ADDENDUM NO. 01
December 11, 2025

To Drawings and Specifications dated December 05, 2025.

PKG 3B – GPHS ATHLETICS, ACADEMIC & MULTI-PURPOSE FACILITY

Prepared by: PBK
11 Greenway Plaza, 22nd Floor
Houston, TX 77046-1104
PBK Project No: 240539

FINISH SCHEDULE

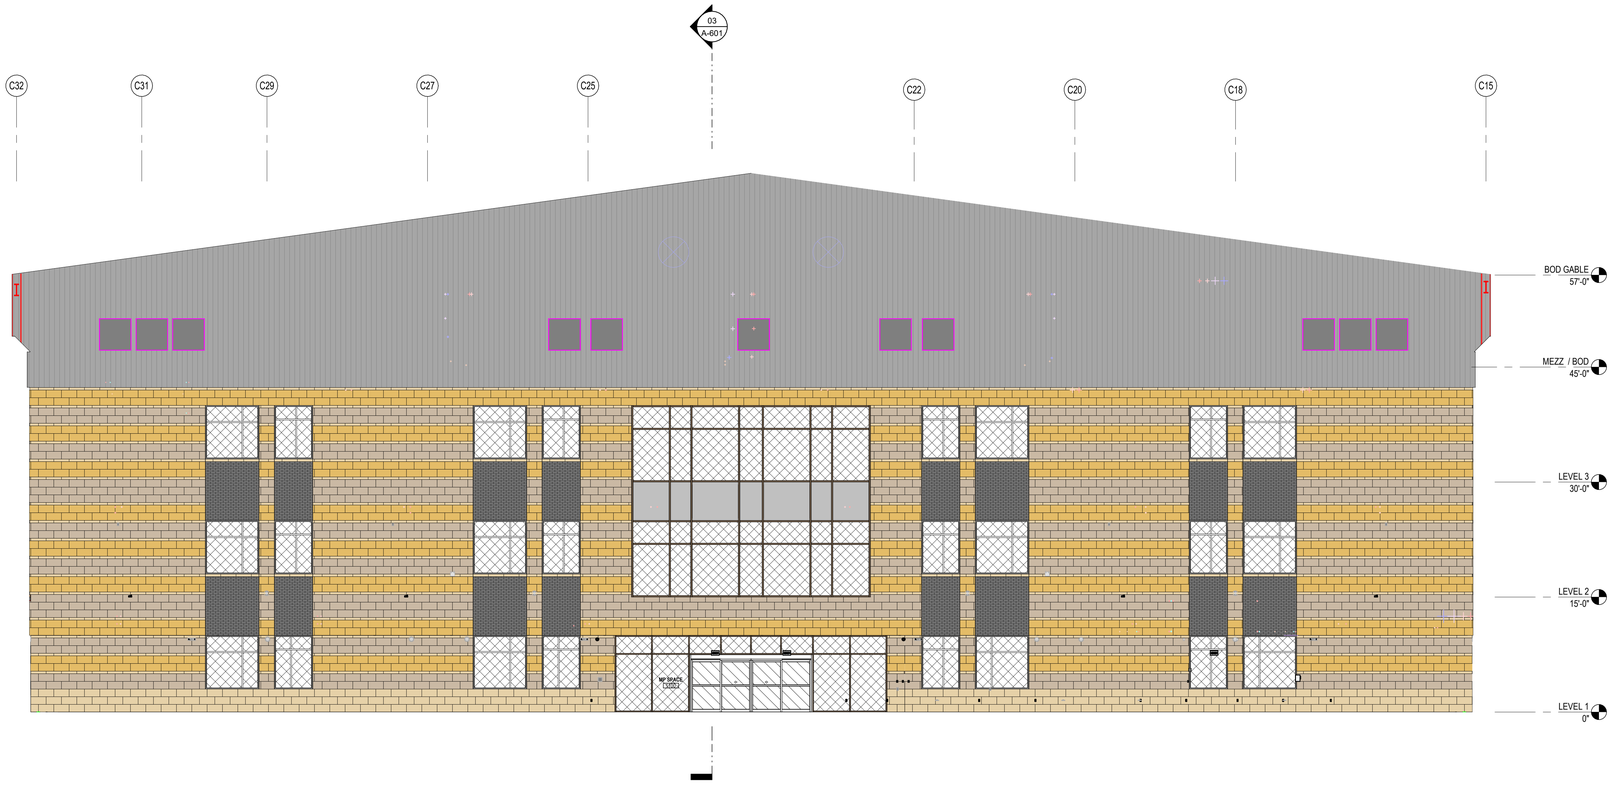
Question 07: The finish schedule on A-900 indicates ARC1 panels are on an accent wall at reception. There is no reception room on the plans and no indication of where ARC1 panels would be location. Can you clarify where the ARC1 panels are located?

Question 08: The finish schedule on A-900 indicates ARC11, ARC12 & ARC13 are on the ceiling in the Library. There is no Library (or Media Center) indicated on the plans. Nor is there any indication of hexagon ceiling clouds on the RCP's. Please provide intended location of these ceiling clouds.

i. Response: Confirmation, to be deleted off. Those are to go into Phase 4. Finish Schedule has been updated for ADD 1.

i. Response: Confirmation, to be deleted off. Those are to go into Phase 4. Finish Schedule has been updated for ADD 1.
